Access Compliance Report

Public Rights-of-Way

(Curb Ramps)

Intersection ID: 49701	Main Street: SCOTTSMAN_TRACE_DR	Cross Street: HIGHLAND_MEADOW_RD	Location: NW
ADA ID: E59532617FD7	Ramp Type: Perp	Initial Pass/Fail: Fail	Overall Compliance: No
Severity Score: 13.75			
Codes/Mitigation Info/Possible Solution		Field Measurements/Component Compliance

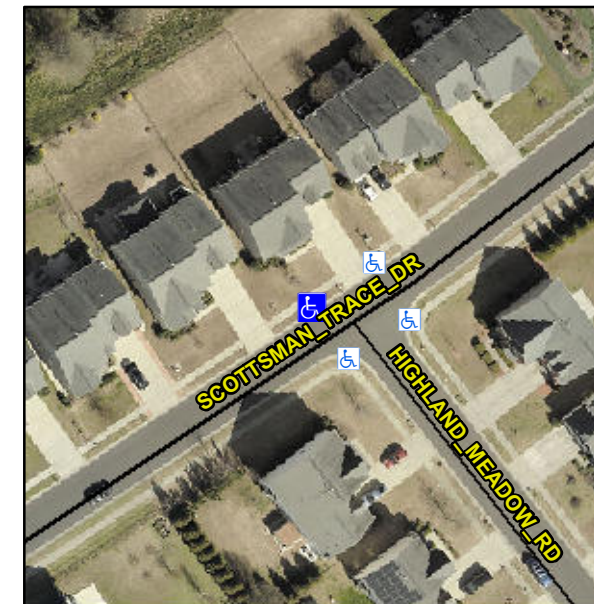
R304.2.2, R304.5.3

Compliance	Description	Data	Compliance	Description	Data
N/A	Ramp Length (in)	47.0	No	Ramp Slope (%)	9.0
Yes	Ramp Width (in)	48.0	No	Ramp XSlope (%)	3.9
N/A	Flare Type LT	N/A	N/A	Flare Type RT	N/A
N/A	Flare Slope LT (%)	N/A	N/A	Flare Slope RT (%)	N/A
N/A	Flare Traversable LT?	N/A	N/A	Flare Traversable RT?	N/A
N/A	Landing Length (in)	N/A	N/A	DWS Provided?	N/A
N/A	Landing Width (in)	N/A	N/A	DWS Contrast?	N/A
N/A	Landing Slope (%)	N/A	N/A	DWS Length (in)	N/A
N/A	Landing X Slope (%)	N/A	N/A	DWS Full Width?	N/A
N/A	Landing Curb? (Y/N)	N/A	N/A	DWS Offset (in)	N/A
N/A	Shared Landing?	N/A			
N/A	Gutter Ponding?	N/A	N/A	Gutter Slope (%)	N/A
N/A	Gutter Lip Ht (in)	N/A	N/A	Gutter X Slope (%)	N/A
N/A	Painted X Walk1?	No	N/A	Painted X Walk2?	N/A
	X Walk 1 Direction	To SE		X Walk 2 Direction	N/A
N/A	X Walk 1 Width (in)	N/A	N/A	X Walk 2 Width (in)	N/A
	X Walk 1 Slope (%)	4.3		X Walk 2 Slope (%)	N/A
	X Walk 1 X Slope (%)	2.8		X Walk 2 X Slope (%)	N/A

Remove & Replace Entire Ramp.
